ASME CODE
CLASSIFICATION FOR CONTAINMENT PENETRATIONS
HVAC-1 AND HVAC-2

Engineering Evaluation Number 93-02

Revision 1

Subject: Seabrook Station
Containment Penetrations -
ASME Code Questions

Figure 1- Typical Charpy Impact and Slow-Bend Curves for Ferritic Steels (Ref. 1, Figure 4.46)

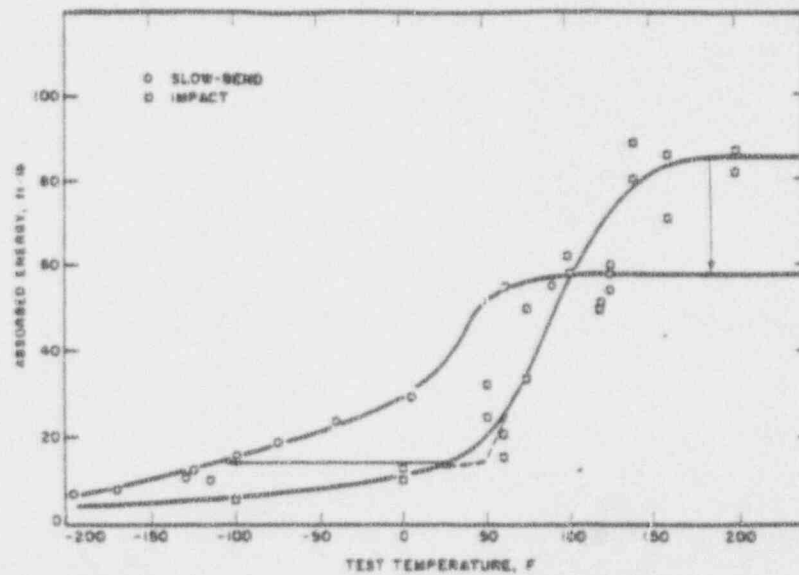
The typical Charpy curve is based on testing done at a high loading rate characterized as "impact" conditions. However, if the loading rate is changed to reflect rates seen in actual service, the energy absorption curve shifts. This results in higher energy absorption at lower temperatures. The slow-bend curve of Figure 1 shows the typical shift for a steel similar to A-105.

Figure 2- Projected Slow-Bend Impact Properties Based on A-302-B Steel (sketched from Ref. 1, Figure 4.46)

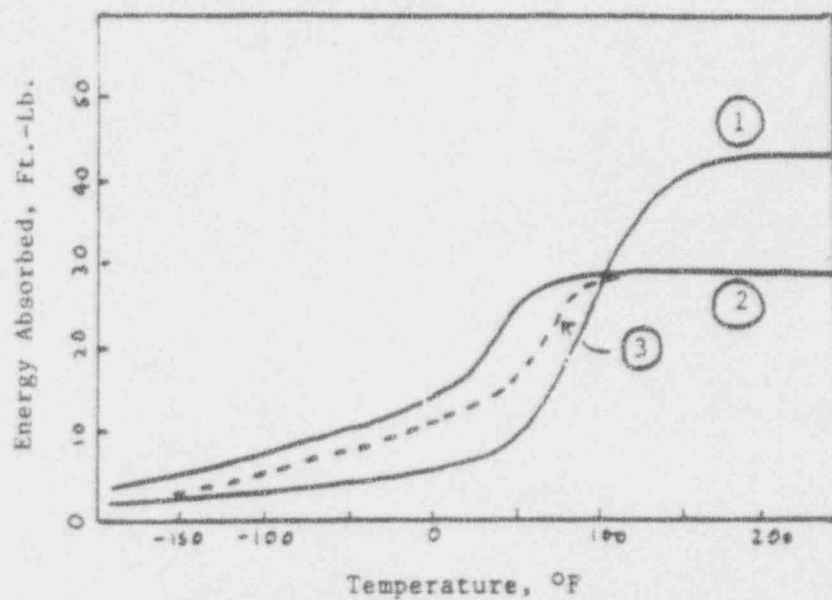
The 302-B curves for dynamic and slow-bend testing are sketched in Figure 2. The following characteristics of the dynamic curve should be noted:
